**MODIFICATION INSTRUCTIONS**  
**for the**  
***Kodak X-Omat* MULTILOADER 300**  
**Service Code: 3058**  
**Modification No. 35**

***Kodak X-Omat* 270 RA PROCESSOR**  
**Service Code: 3059**  
**Modification No. 21**

***Kodak X-Omat* 180 LP and 180 LPS PROCESSORS**  
**Service Codes: 3227, 3198**  
**Modification No. 8**  
**Type 1 Selective**

- Purpose:** To improve the reliability of the PROCESSOR by:
- moving the connections for the DRYER OVER-TEMPERATURE and the DRYER THERMISTOR to outside of the TANK, to reduce corrosion of the CONNECTORS
  - installing a new YOKE AND PIN ASSEMBLY, to minimize the possibility of diluting the fixer
  - installing plastic SPROCKETS in the DRYER RACK, to eliminate corrosion of the SPROCKETS

H104\_0414ECB  
H104\_0414EA

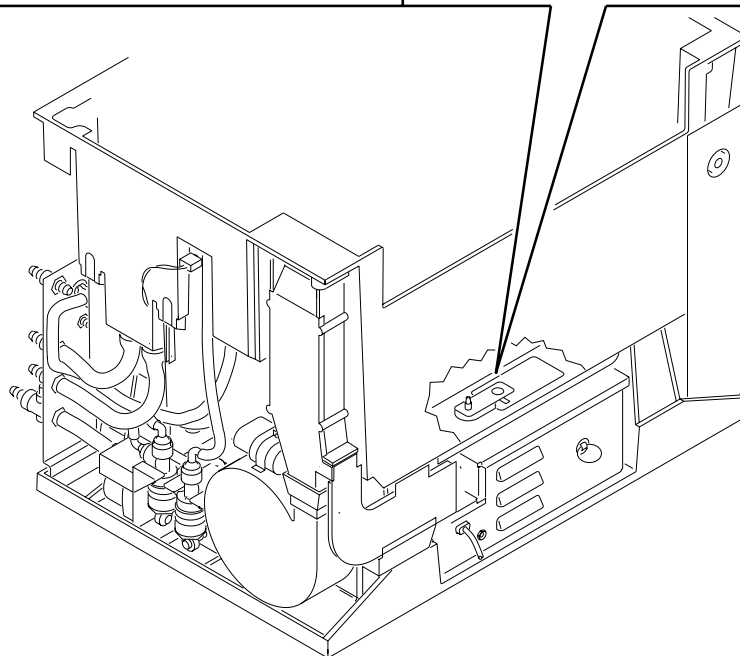
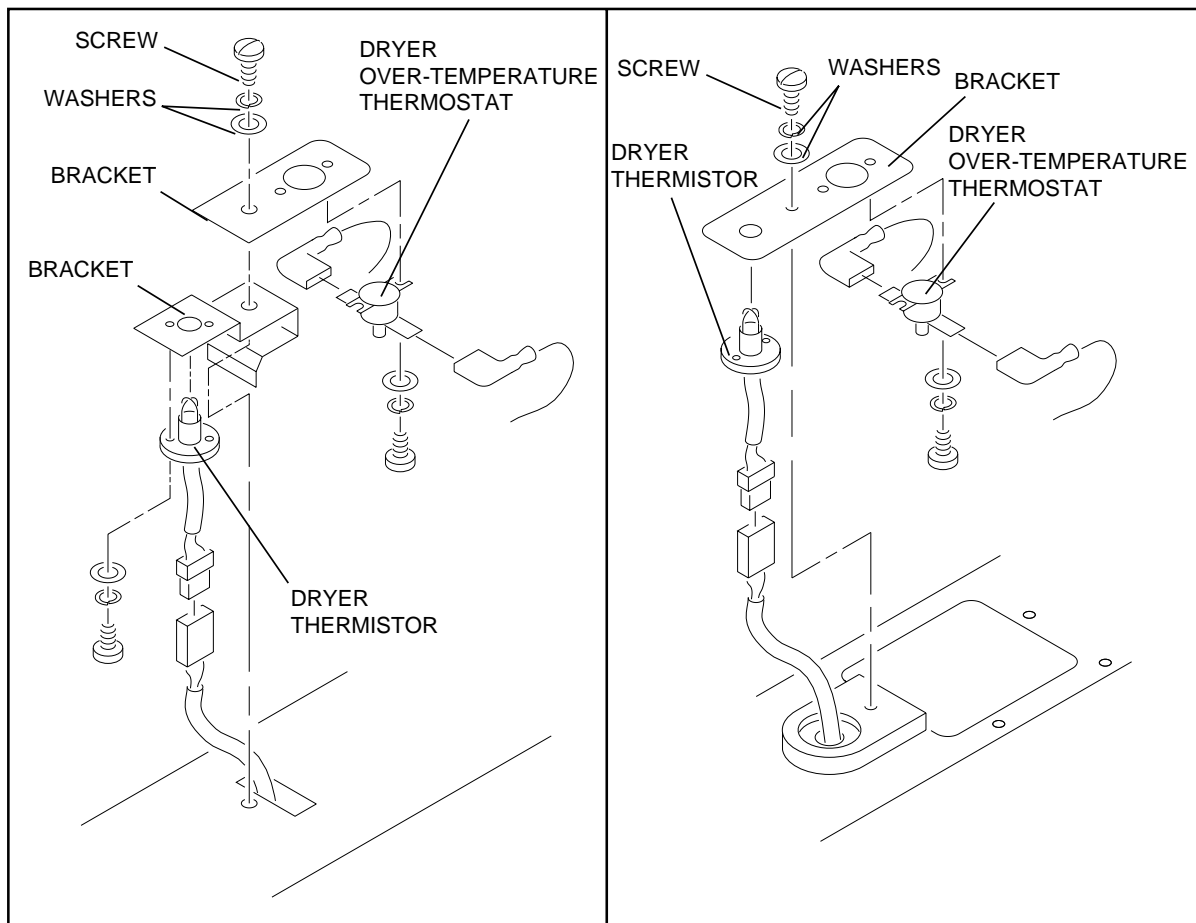
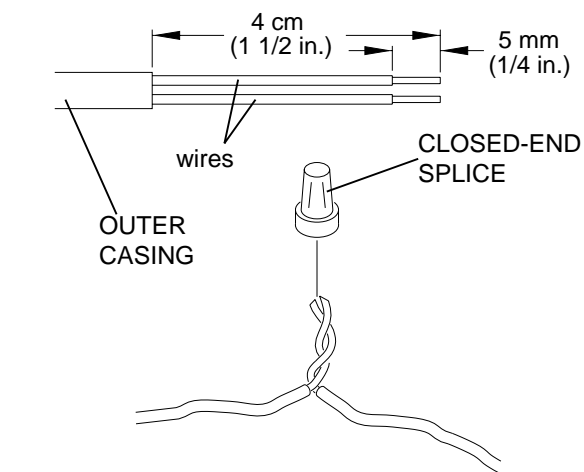
## Installing the New DRYER THERMISTOR and OVER-TEMPERATURE THERMOSTAT

PROCESSORS can have 1 of 2 styles of BRACKETS. See the figure above that matches your PROCESSOR.

- [1] Remove the BRACKET(S) for the DRYER THERMISTOR and the DRYER OVER-TEMPERATURE THERMOSTAT from the PROCESSOR.

- [2] Remove the DRYER THERMISTOR and the DRYER OVER-TEMPERATURE THERMOSTAT from the BRACKET(S).
- [3] Disconnect the wires from the DRYER OVER-TEMPERATURE THERMOSTAT. Discard the THERMOSTAT.

- [4] Disconnect the DRYER THERMISTOR at the CONNECTOR. To free the wires, cut any TIE WRAPS necessary. Discard the THERMISTOR.
- [5] Remove the DRYER BLOWER ASSEMBLY from the PROCESSOR.

- (a) Remove the 3 SCREWS.
  - (b) Bend the BLOWER SLEEVE down to release the BLOWER ASSEMBLY from the PLENUM.
- [6] From the nondrive side of the PROCESSOR, pull the wires for the DRYER OVER-TEMPERATURE and the DRYER THERMISTOR outside the TANK.

- [7] Prepare the new wires. See the figure below.
  - (a) Cut the CONNECTOR from the new DRYER OVER-TEMPERATURE THERMOSTAT. Discard the CONNECTOR.
  - (b) Remove approximately 4 cm (1½ in.) of the OUTER CASING from around the wires.

- (c) Remove approximately 5 mm (¼ in.) of the insulation from the wires.
  - (d) Do Steps (a), (b), and (c) for the DRYER THERMISTOR.
- [8] Install the new DRYER THERMISTOR and the DRYER OVER-TEMPERATURE THERMOSTAT to the BRACKET(S). Use the SCREW(S) and WASHER(S) from Step 2 above.

- [9] Route the wires for the new DRYER THERMISTOR and DRYER OVER-TEMPERATURE THERMOSTAT from inside the TANK to outside.
- [10] Install the BRACKET(S) on the TANK. Use the SCREW and WASHERS from Step 1 on Page 4.

H104\_0595ACA  
H104\_0595AA

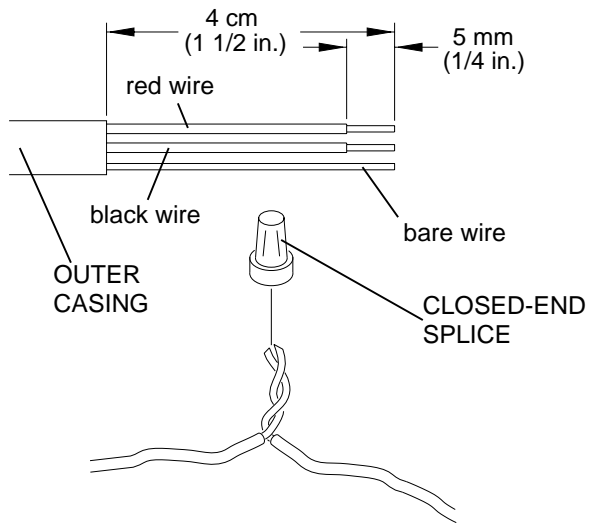
## Connecting the New DRYER OVER-TEMPERATURE THERMOSTAT

Do the following steps outside the TANK, on the nondrive side of the PROCESSOR.

- [1] Prepare the existing wires.
  - (a) Cut approximately 28 cm (11 in.) from the existing wires for the DRYER OVER-TEMPERATURE THERMOSTAT.
  - (b) Remove approximately 4 cm (1½ in.) of the OUTER CASING from around the wires.
  - (c) Remove approximately 5 mm (¼ in.) of the insulation from the wires.
- [2] Connect the new wires to the existing wires.
  - (a) Twist the end of one of the existing wires around the end of one of the wires coming from the new DRYER OVER-TEMPERATURE THERMOSTAT.
  - (b) Insert the twisted wire ends into one of the CLOSED-END SPLICES from the Mod Kit. Use TL-2020 (or the equivalent) to close the SPLICE.

[3] Do Step 2 for the other wire.

[4] Move the wires to positions that will not have contact with moving parts or be compressed by the PANELS.

H104\_0596ACA  
H104\_0596AA

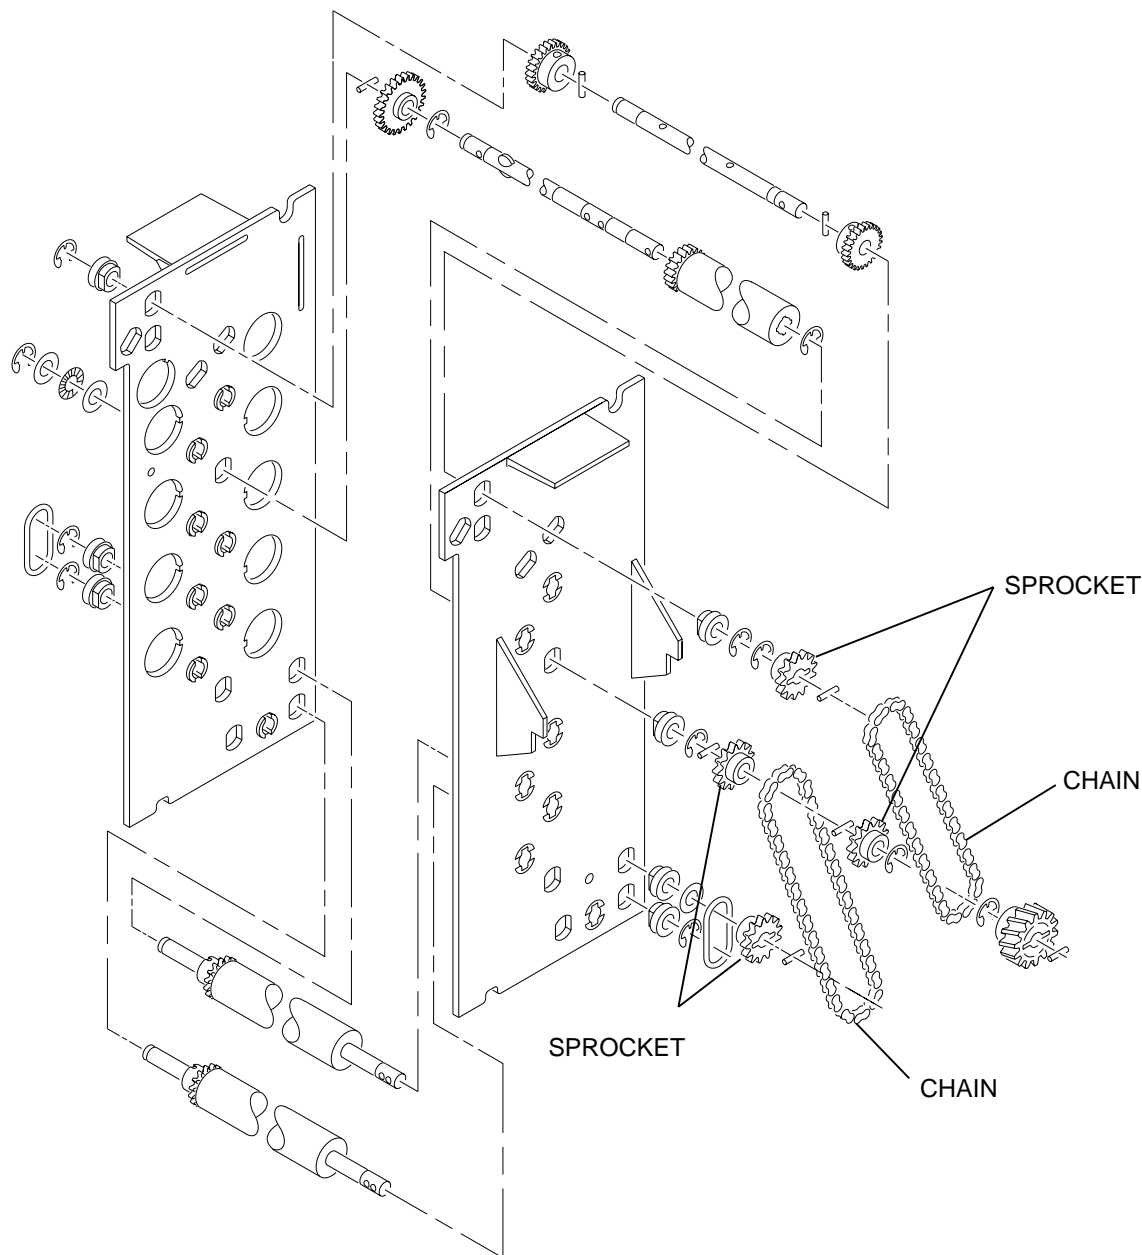
## Connecting the New DRYER THERMISTOR

- [1] Prepare the wires for the new DRYER THERMISTOR. See Step 1 on Page 5.
- [2] Twist together each pair of wires, insert into a CLOSED-END SPLICE, and close the SPLICE:
  - 2 red wires
  - 2 black wires
  - 2 bare ground wires

The bare ground wires do not need insulation.

- [3] Move the wires to positions that will not have contact with moving parts or be compressed by the DRYER BLOWER.
- [4] Install the DRYER BLOWER in the PROCESSOR.
- [5] Check that the BLOWER SLEEVE is in the correct position, and no leakage of air occurs.

H104\_0504DCA  
H104\_0504DA

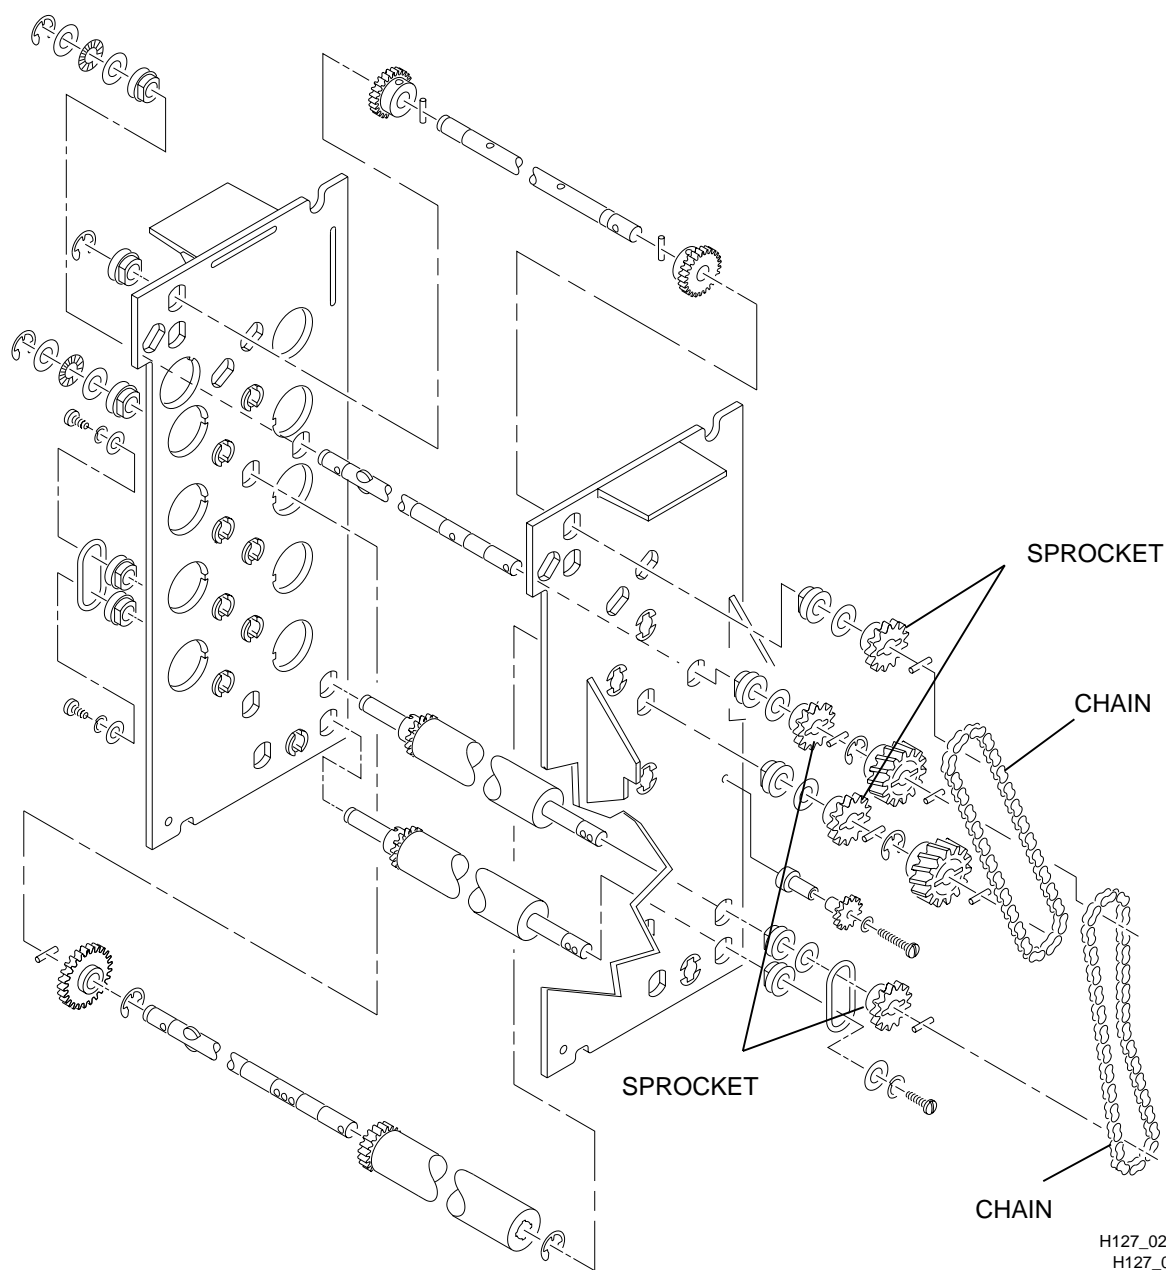
## Installing the New Plastic SPROCKETS in a 270 RA PROCESSOR or a MULTILOADER 300

[1] Install the 4 new plastic SPROCKETS for the CHAINS in the DRYER RACK. See the figure above.
